Proposal for amendment of ECE/TRANS/WP.29/GRSG/2024/35

(Reversing motion)

Submitted by the expert from Republic of Korea

Figure 1 **Example of the Tail Gate of Cargo Trucks**

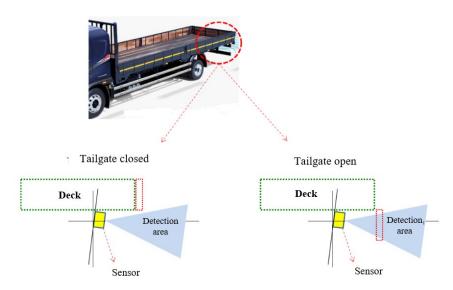
- 1. The vehicle conditions of the test methods for rear-view field of vision are clearly specified in the annex 9 in this Regulation, but not in the case of detection systems in annex 10. This is a problem of inconsistency between the rear-view field of vision and the detection systems that may also cause ambiguity in conducting the test for detection systems.
- 2. In addition, the test conditions should specify that not only rear hatches or trunk lids but also the tail gates of cargo trucks and van-type vehicles should be closed or latched in the normal conditions of vehicle operation during the test. For additional information on this matter, please refer to the following figures.

"1.3.3.4. Rear hatches and, trunk lids- and tailgates.

> If the vehicle is equipped with rear hatches, or trunk lids or tailgates, they are closed and latched in their normal vehicle operating condition."
